INNER WEST

DEVELOPMENT ASSESSMENT REPORT

Application No.	DA/2020/0771
Address	86 Rowntree Street BIRCHGROVE NSW 2041
Proposal	Alterations and additions to existing dwelling house
Date of Lodgement	18 September 2020
Applicant	Mr Leonard V Hambleton Ms Rhian N Czech
Owner	Mr Leonard V Hambleton Ms Rhian N Czech
Number of Submissions	0
Value of works	\$150,000.00
Reason for determination at Planning Panel	Clause 4.6 variation exceeds 10%
Main Issues	Variation to Floor Space Ratio Development Standard Variation to Site Coverage Development Standard Variation to Soft Landscaping Development Standard Form of rear skillion dormer addition
Recommendation	Approval with Conditions
Attachment A	Recommended conditions of consent
Attachment B	Plans of proposed development
Attachment C	Clause 4.6 Exception to Development Standards
Attachment D	Statement of Heritage Significance

Photo 3: Photo of existing rear roof plan where rear skillion dormer to be located. Photo taken from rear first floor verandah looking south.

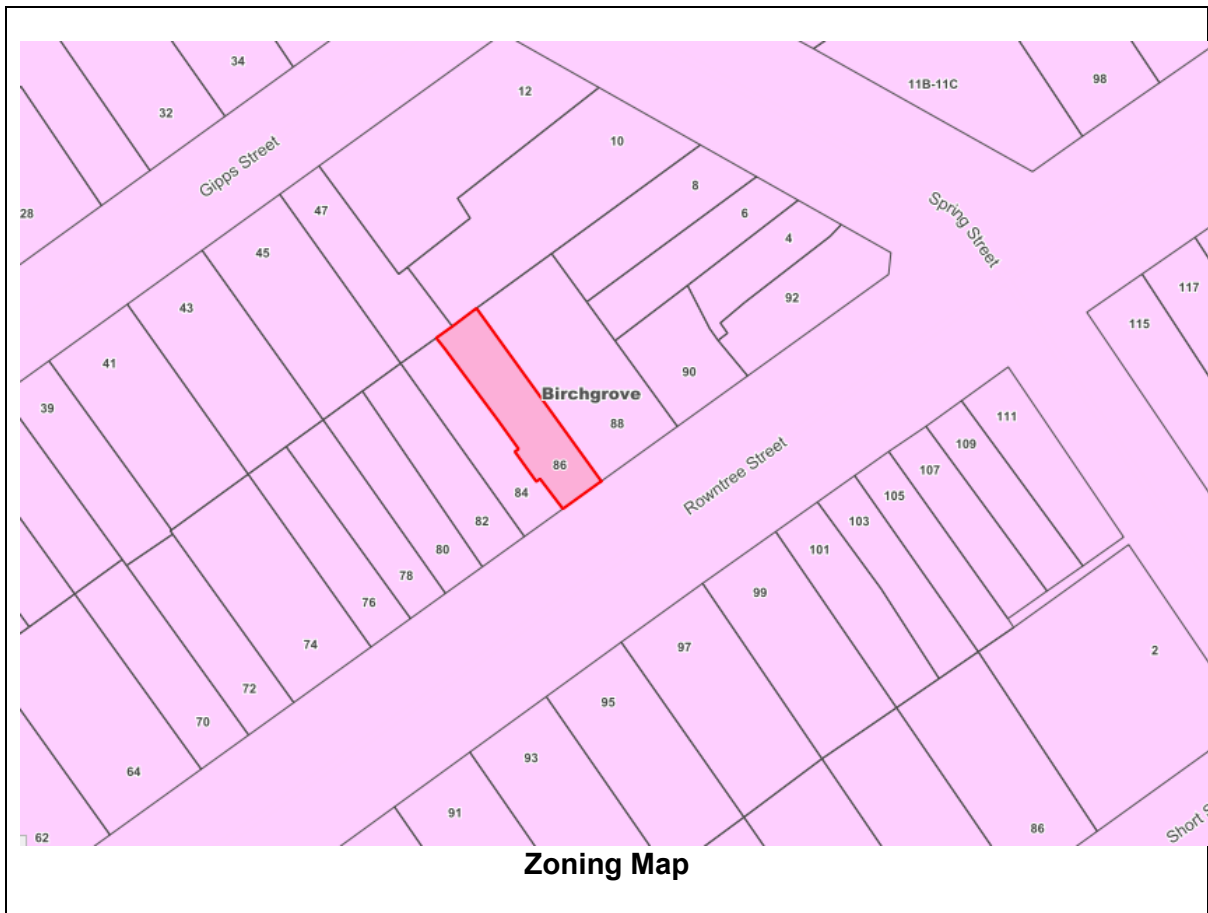
The proposal includes a rear skillion dormer with Juliet style rear glazed doors and colorbond for the side elevations of the dormer. The features of the additions are not considered to satisfy the following objective and control.

Control C5 of C1.3 states that new materials and fenestrations of alterations and additions shall be compatible with the existing building and objective O1a of C1.4 states that development does not represent an unsympathetic alteration or addition to a building.

As detailed above under Clause 5.10 – Heritage Conservation of the LLEP 2013, the site is located in a heritage conservation area. Subject to recommended conditions with regard to the rear skillion dormer it could be altered to satisfy the above control and objective and have a more appropriate form in relation to glazing and use more appropriate materials, which would be a satisfactory outcome.

Figure 1: Part of original section depicting curved skillion dormer.

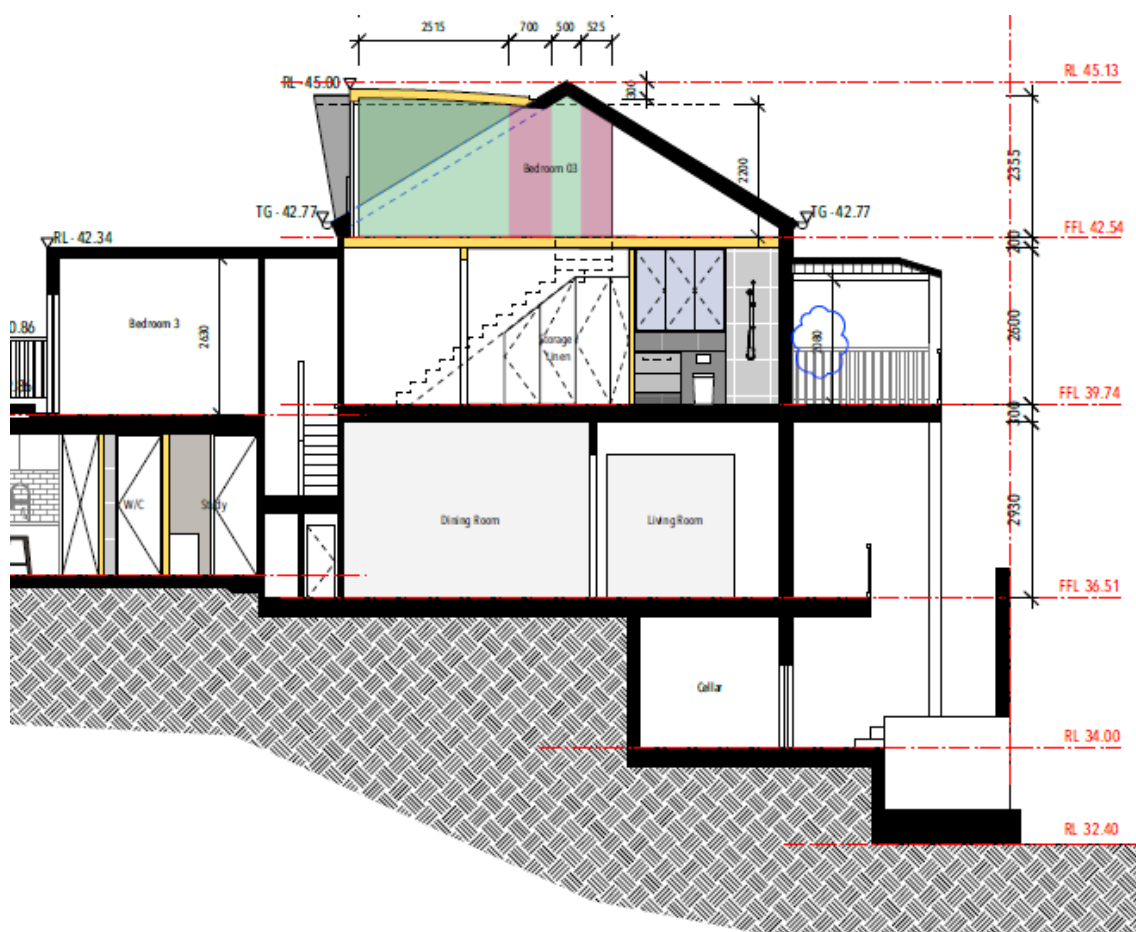
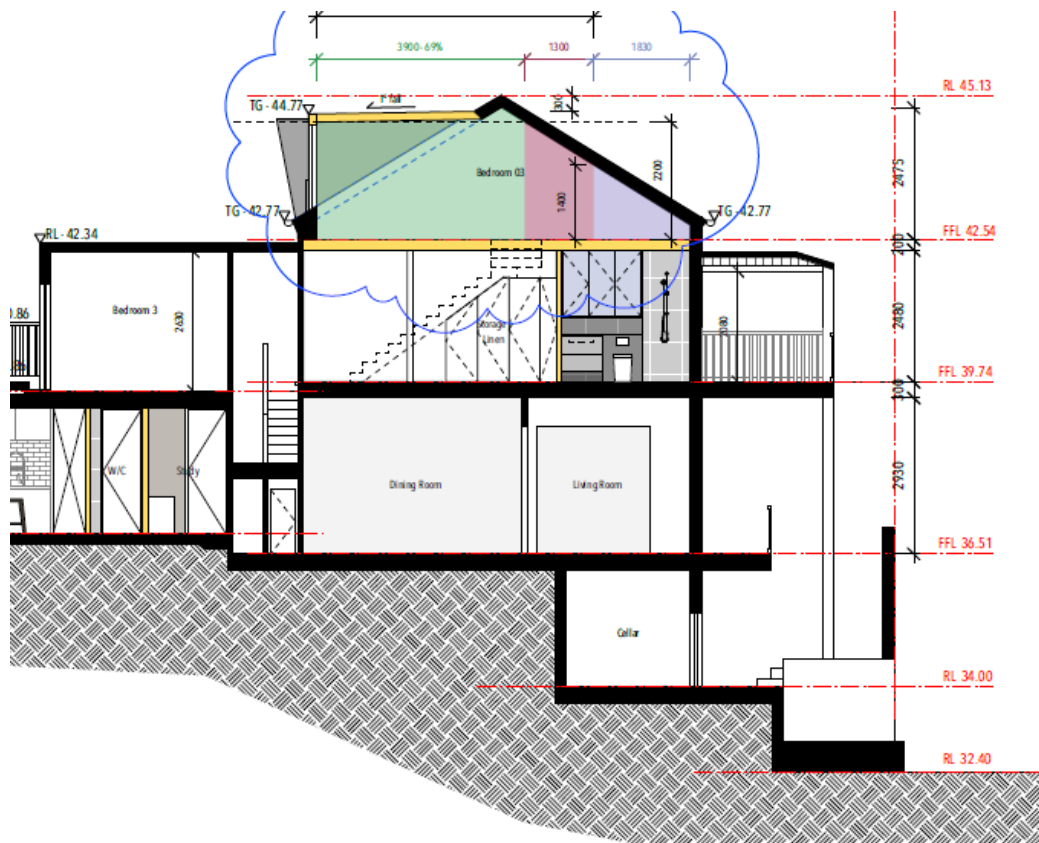
The subject property is a contributory dwelling within the Iron Cove Heritage Conservation Area. The proposal includes a rear skillion dormer window to the rear roof plane in the main gable roof form. The DA was originally submitted with a curved skillion dormer as shown below in Figure 1. The application was referred to Council’s heritage advisor who advised that the curved form of the dormer was not supported, that the dormer should slope in the same direction as the roof, that the glazing in the dormer would need to be reduced and use timber framed windows, not have fins walls and that the side walls of the dormer (cheeks) be a more appropriate material than the proposed colorbond.

The applicant was contacted and has altered the form of the dormer such that it is able to be conditioned to comply with the outstanding heritage requirements. This was achieved by lowering the RL of the floor of the attic level to achieve required ceiling heights. Figure 2 below shows the new proposed form of the rear skillion dormer.

Figure 2: Part of amended section detailing a more traditional dormer form

The applicant has only provided an amended section and floor plan at this stage and they are open to the dormer being conditioned to comply with the heritage officer's recommended requirements which include the following;

- The proposed glazing to the northern (rear) elevation of the dormer is to be replaced with vertically proportioned timber framed windows which have a maximum height of 1.2m;
- The window frames, front lining boards, fascias and barge boards are to be painted timber;
- The side elevations (cheeks) of the dormer are to be weather boards, or shingles or fibre cement sheet with battens over joints and edges;
- The eave of the rear skillion dormer is to extend past the vertical face of the windows;
- The shade awning above the windows and fin wall extensions on the eastern and western elevations are to be deleted.

AMENDED FLOOR PLAN AS REQUESTED BY COUNCIL

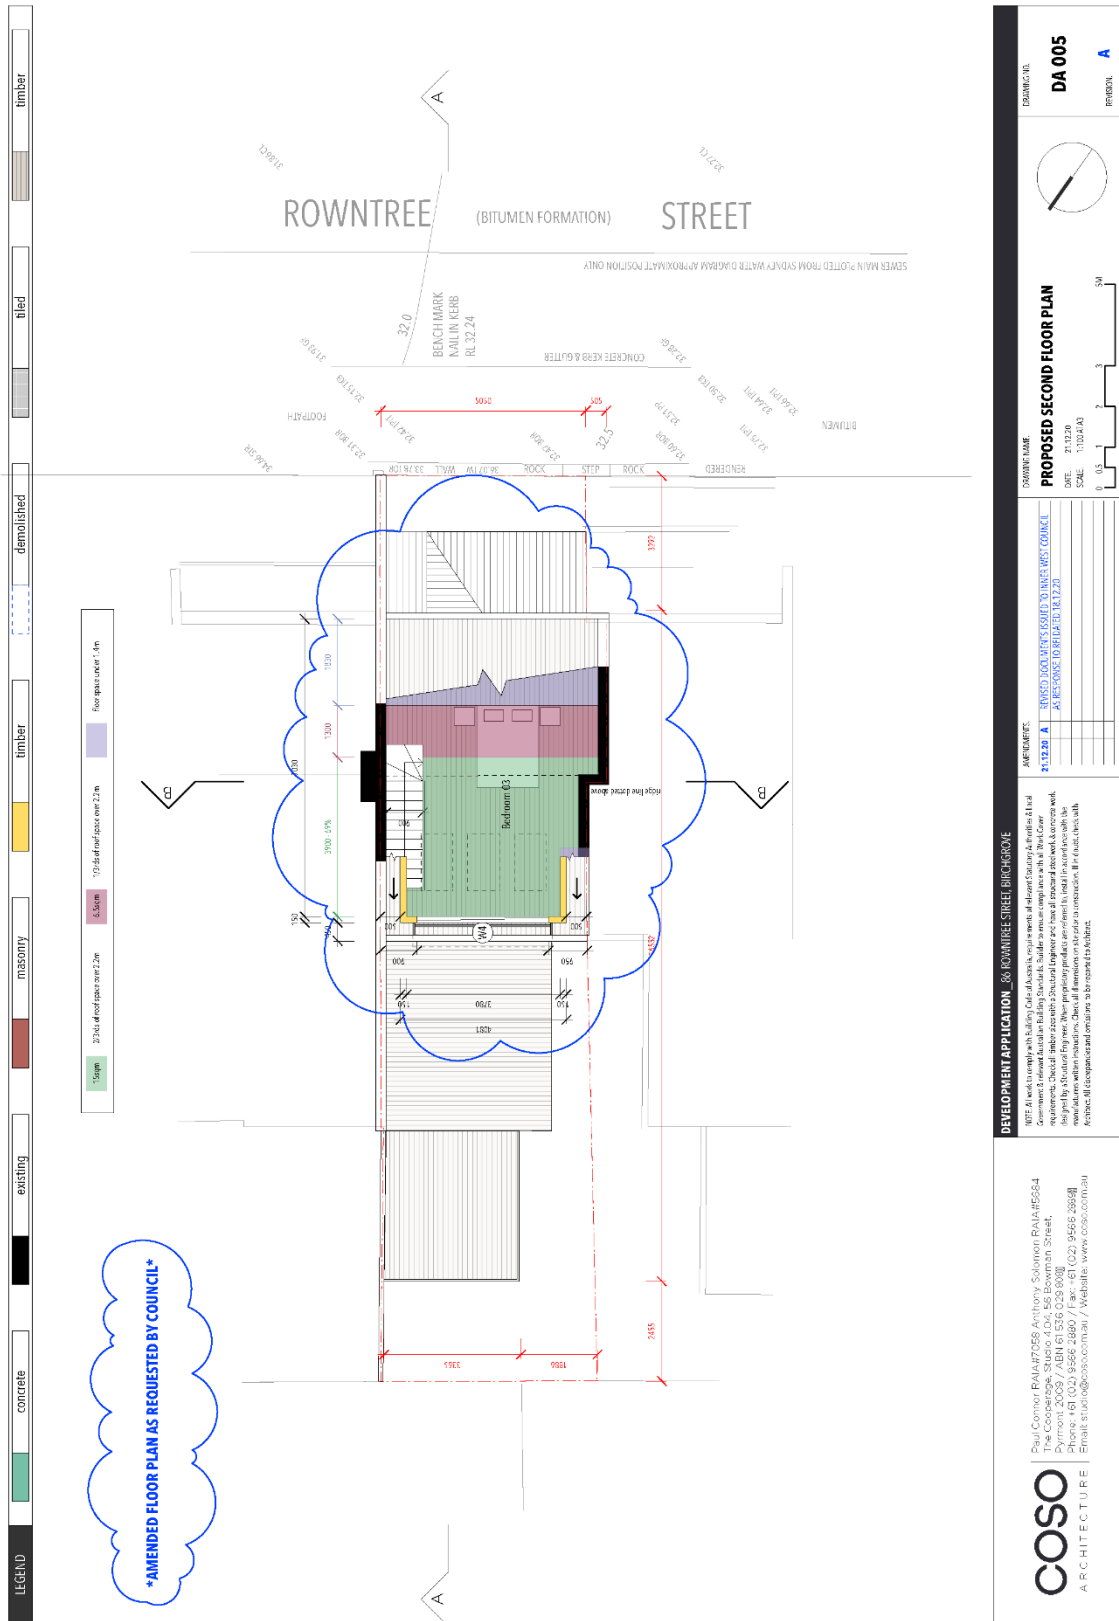
Date	Discussion / Letter / Additional Information
18.12.2020	Email request to applicant to request party wall consent, more detailed floor plan of attic, new 4.6 exceptions for soft landscaping and FSR. Plan of redefinition. Council planner spoke to architect on 18.12.2020 to discuss the above email request.
21.12.2020	Architect submitted 4.6 exception for landscaping and FSR, amended floor plan for attic, amended section which demonstrates ceiling height can work. Planner and architect had a phone call where the architect advised they were happy to accept conditions for more specific details of dormer with regard to windows etc. It was agreed that a condition would be imposed regarding the Plan of Definition requirement.
15.1.2021	Council planner spoke to architect and emailed requesting 4.6 exception for site coverage.
8.02.2021	Architect submitted 4.6 Exception for site coverage.
